CIRCUIT COMPARISON

ChryslerScanner

Original schematic -> current circuit sets

Original: Daniel Laszlo, revision 2.4.0-1, 2026-01-05. Current: Rev C, 24 pages / 329 circuit-probe endpoints.

22 SCI pin 12: VBB / VPP programming switches

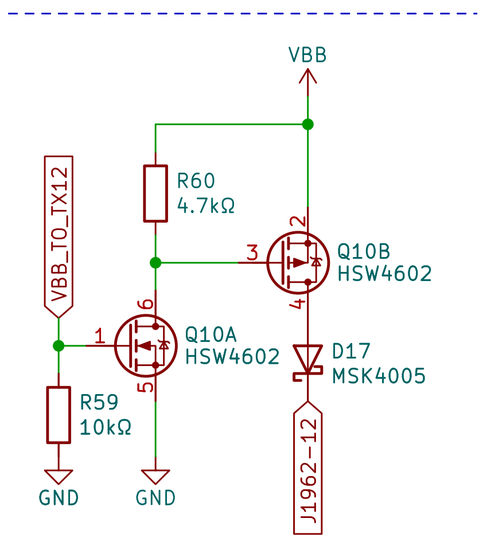
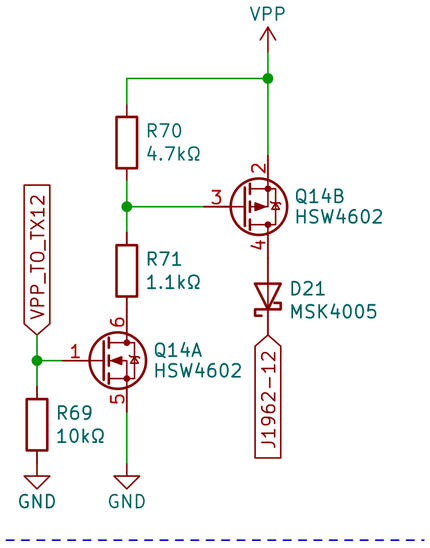
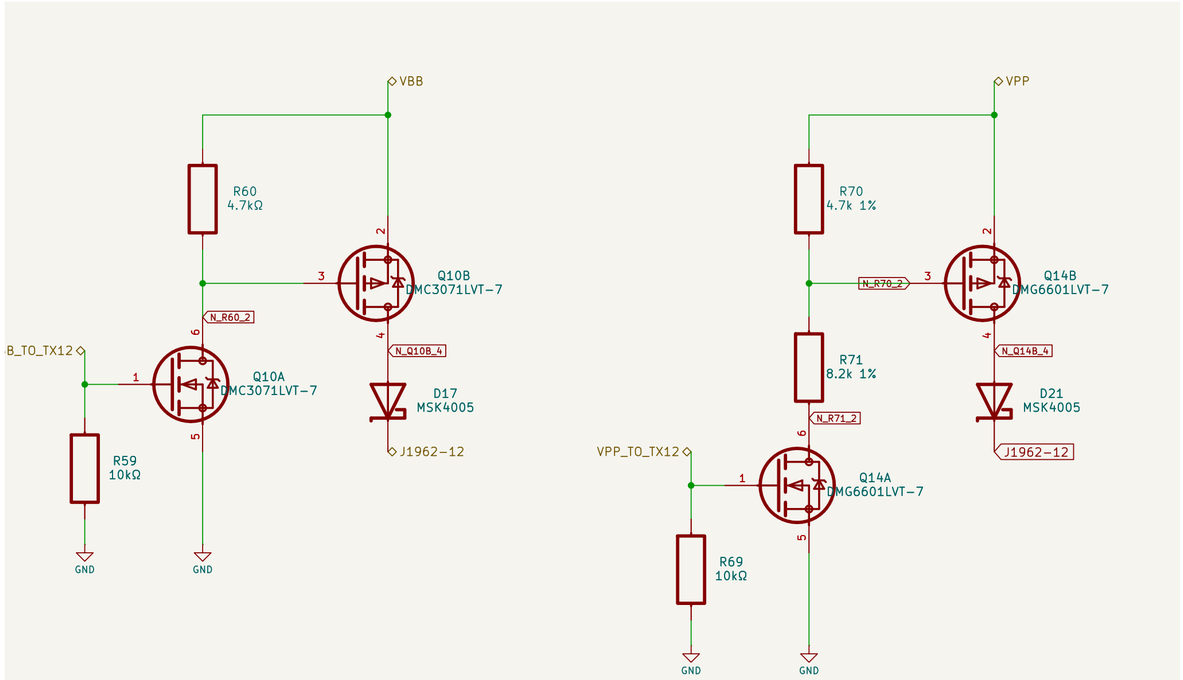
- The two rail-switching branches are paired by vehicle pin on a dedicated page.
- Q8-Q11 and Q12-Q15 use revised FET families. The VPP gate-divider values are intentionally revised to 4.7k / 8.2k; compare current labels rather than assuming identical parts.

23 SCI pin 14: VBB / VPP programming switches

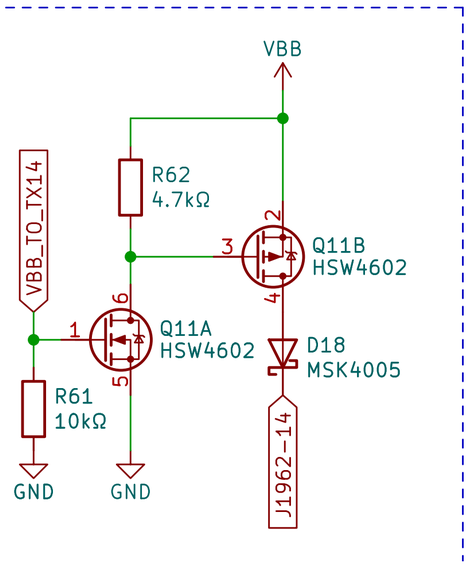
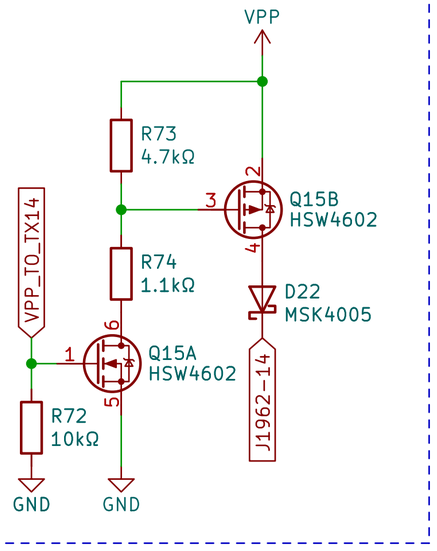
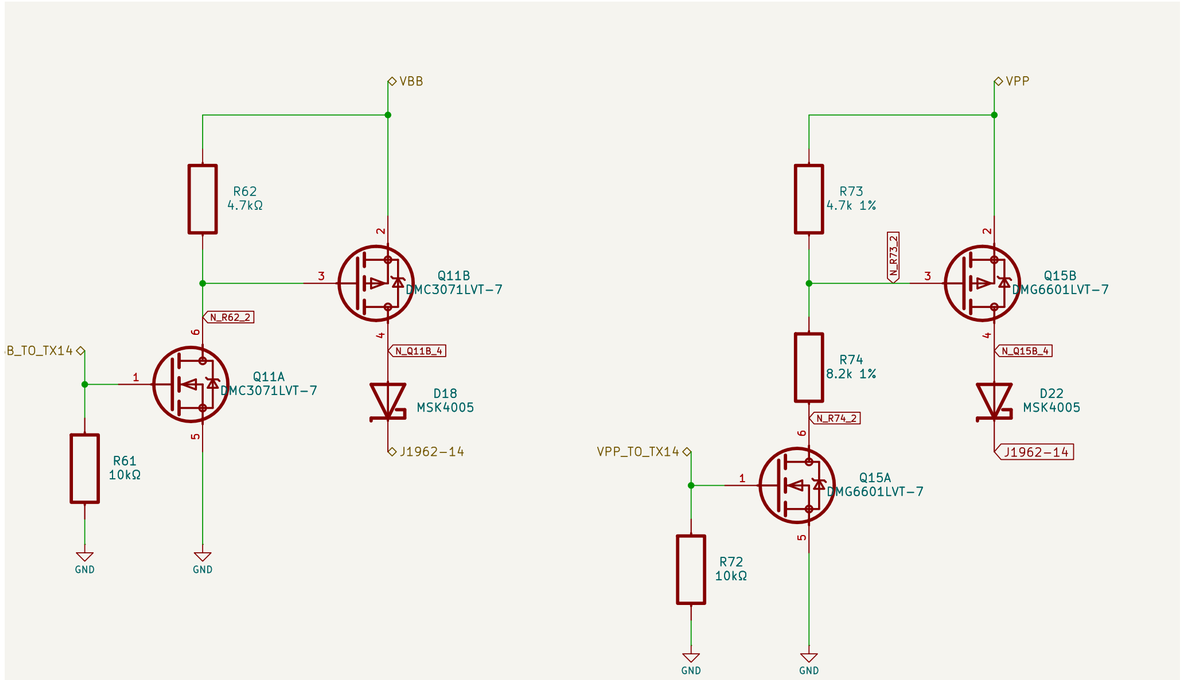
- The two rail-switching branches are paired by vehicle pin on a dedicated page.
- Q8-Q11 and Q12-Q15 use revised FET families. The VPP gate-divider values are intentionally revised to 4.7k / 8.2k; compare current labels rather than assuming identical parts.

24 I2C expander and internal connector

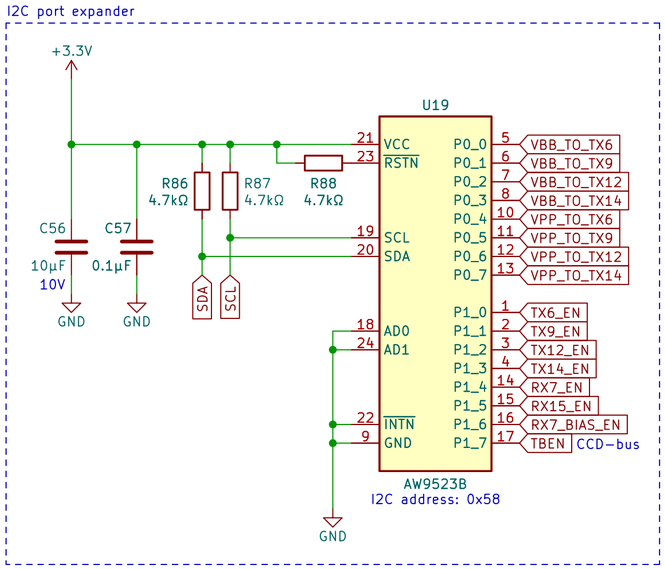
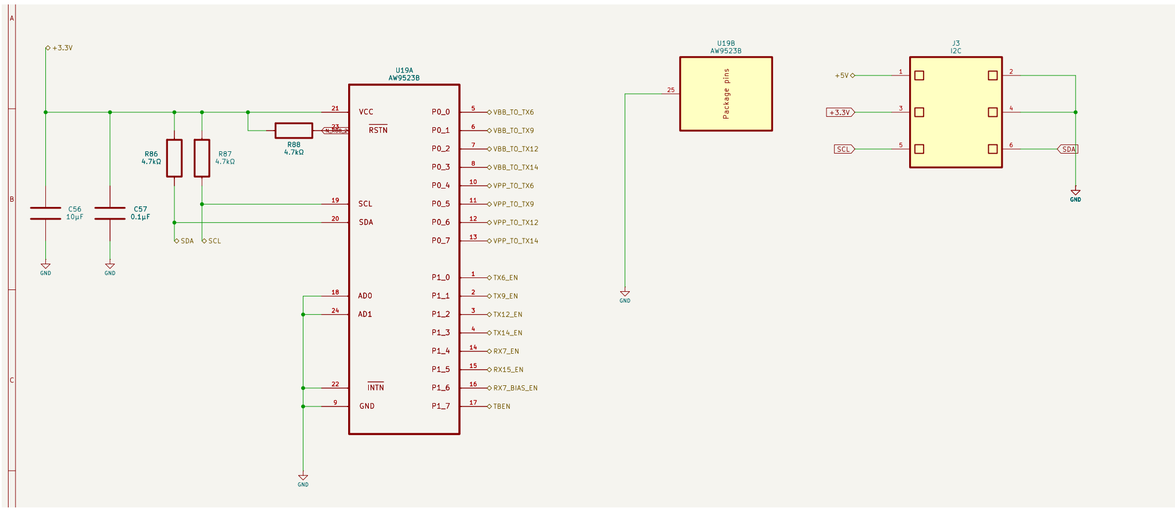
- U19 AW9523B, its 16 output functions, grounded address straps, I2C pull-ups and J3 are retained.
- The reset/permit net N_R88_2 is now driven by the new supervised hardware permit. The original independent reset pull-up is not sufficient by itself to describe the new safety behavior.

25 Status LED drivers

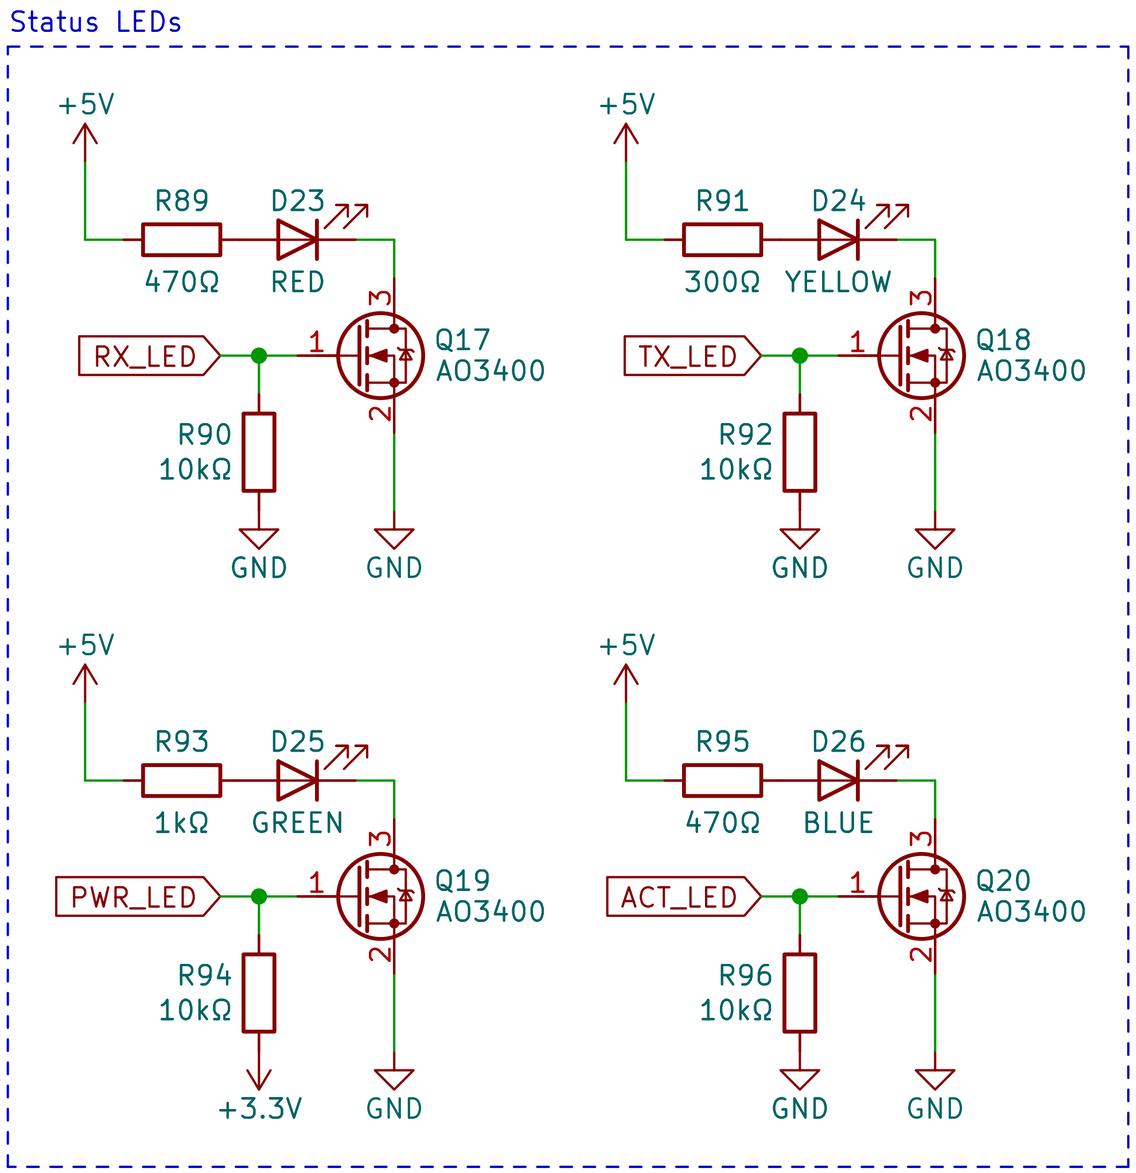
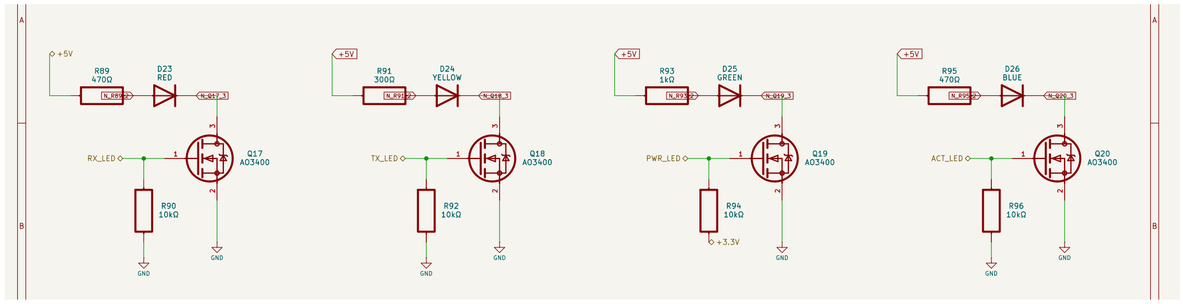
- D23-D26 and Q17-Q20 retain the four LED driver channels.
- The ACT_LED channel is now a dedicated health/permit indication. It must not be driven by the old general-purpose activity-blink code.

26 Integrated microSD logger

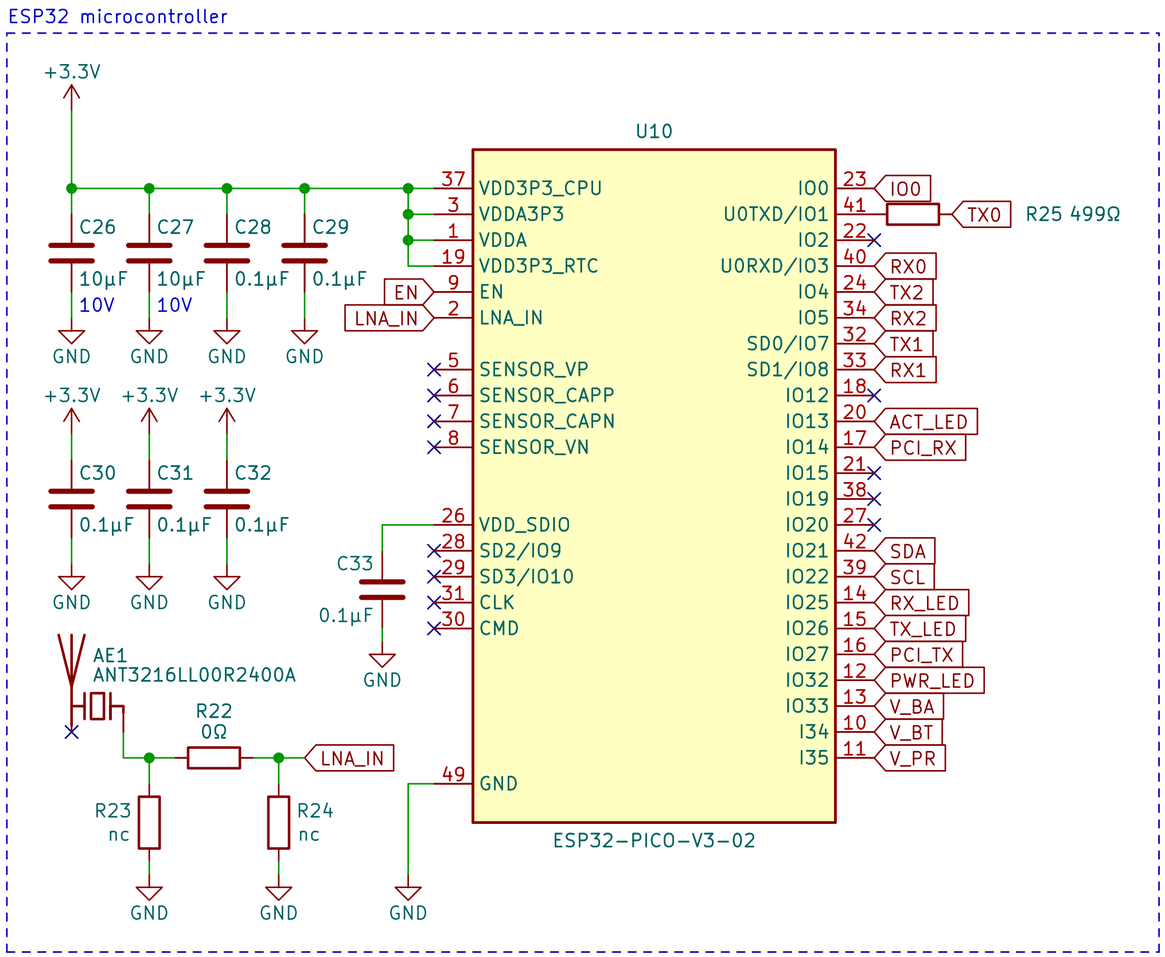
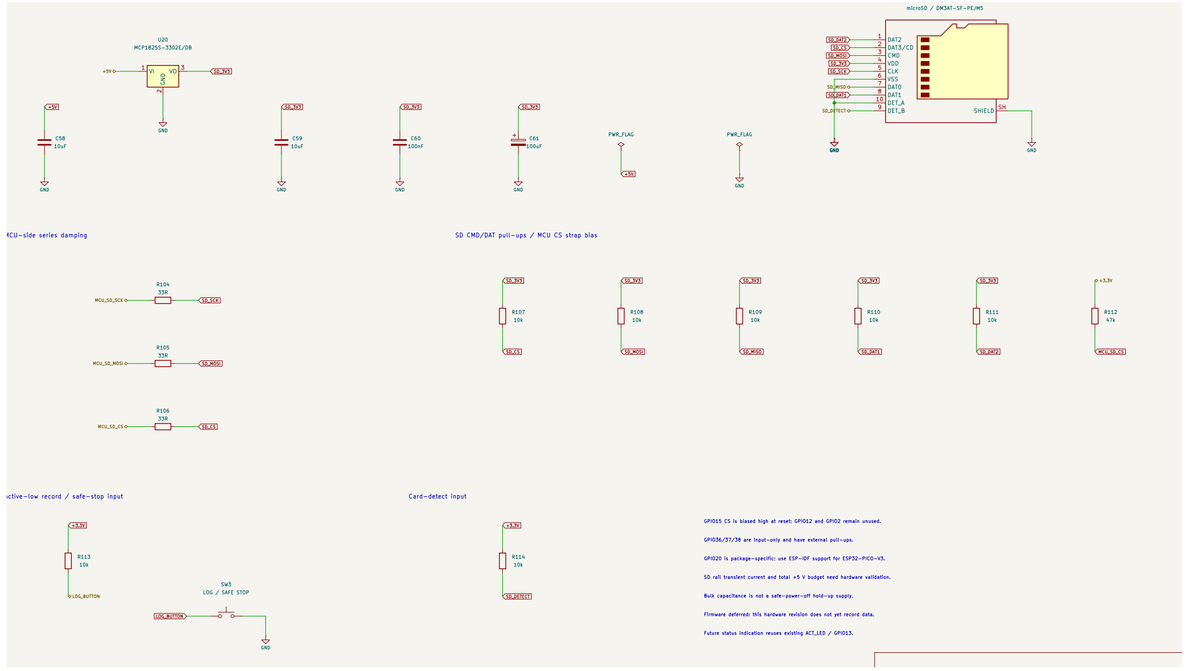
- There is no corresponding microSD block in the original drawing. U20, J4, C58-C61, R104-R114 and SW3 are later additions.
- SD_3V3 regulation, SPI resistors/pull-ups, card detect and logging control use previously unused MCU pins. C61 is now top-side; that physical move does not change the schematic circuit.

27 Added ADC power-off isolation

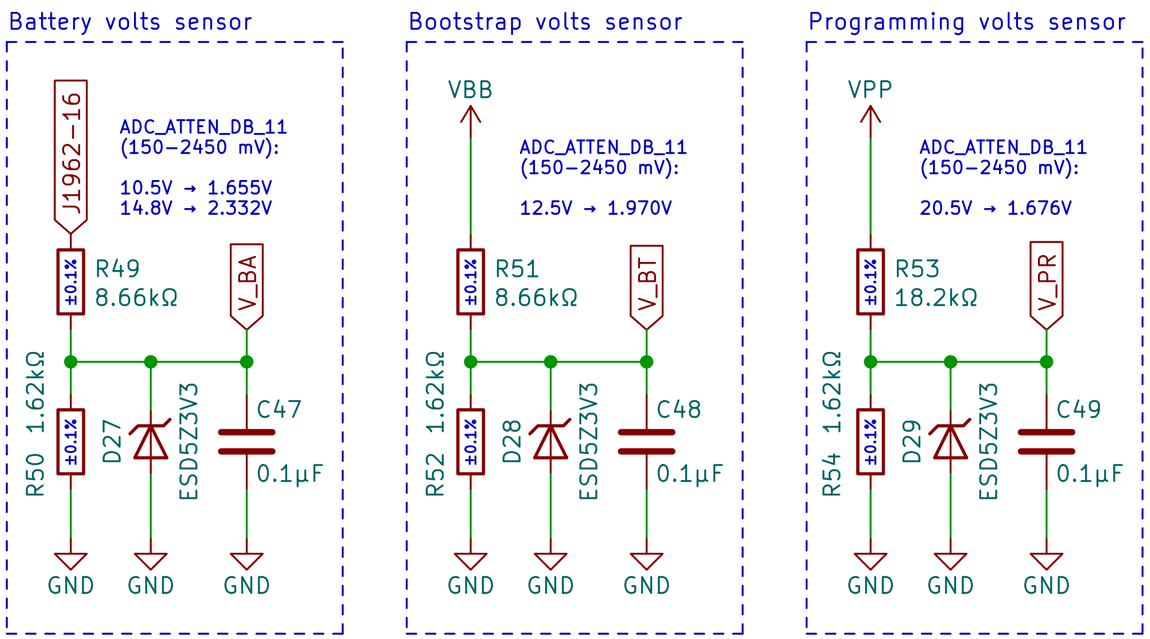
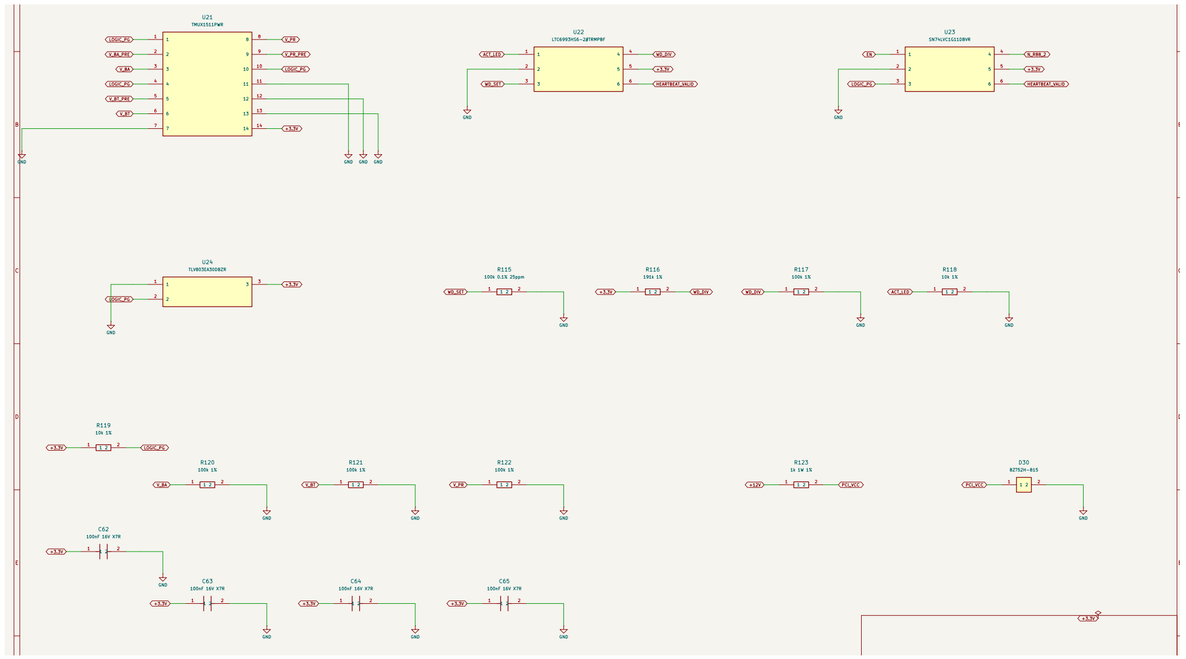
- U21 and R120-R122 are new. The original ADC paths now terminate on *_PRE nets before this isolation stage.
- The additions address powered-off MCU injection; they deliberately depart from the original direct ADC connection. See comparison 16 for the changed divider inputs/ratios.

28 Added supervisor, watchdog and hardware permit

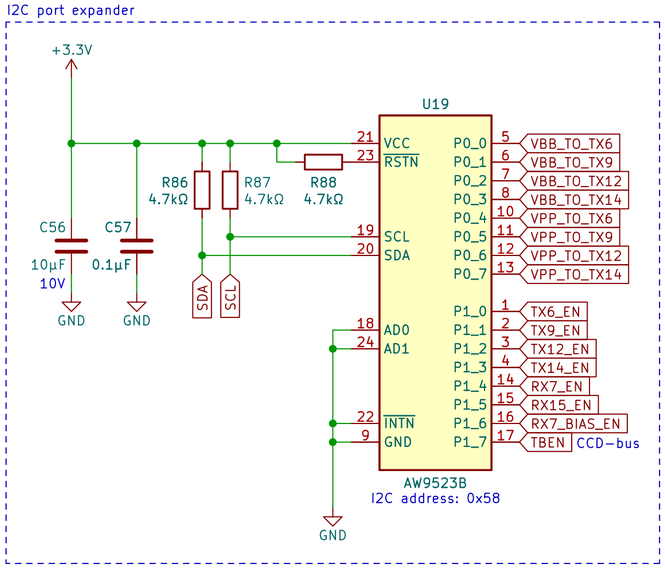
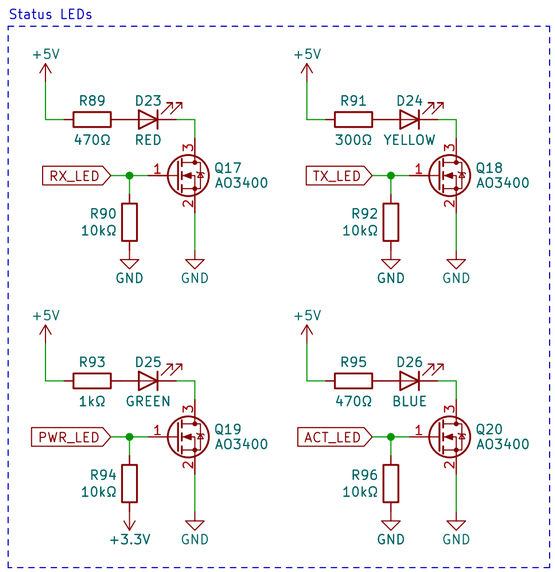
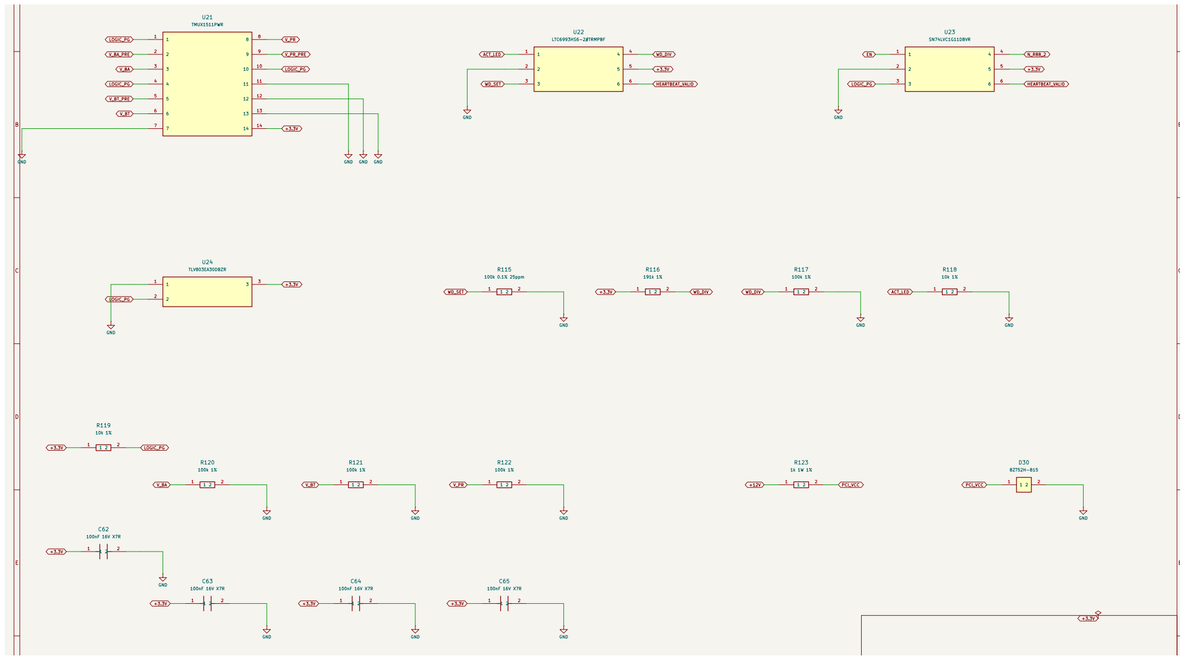
- U22-U24, R115-R119 and associated bypassing implement a new supervised permit, not an original circuit copied to another page.
- Dedicated ACT_LED health pulses and LOGIC_PG / HEARTBEAT_VALID govern N_R88_2. Firmware integration and measured timing remain required; the comparison is not a bench qualification.
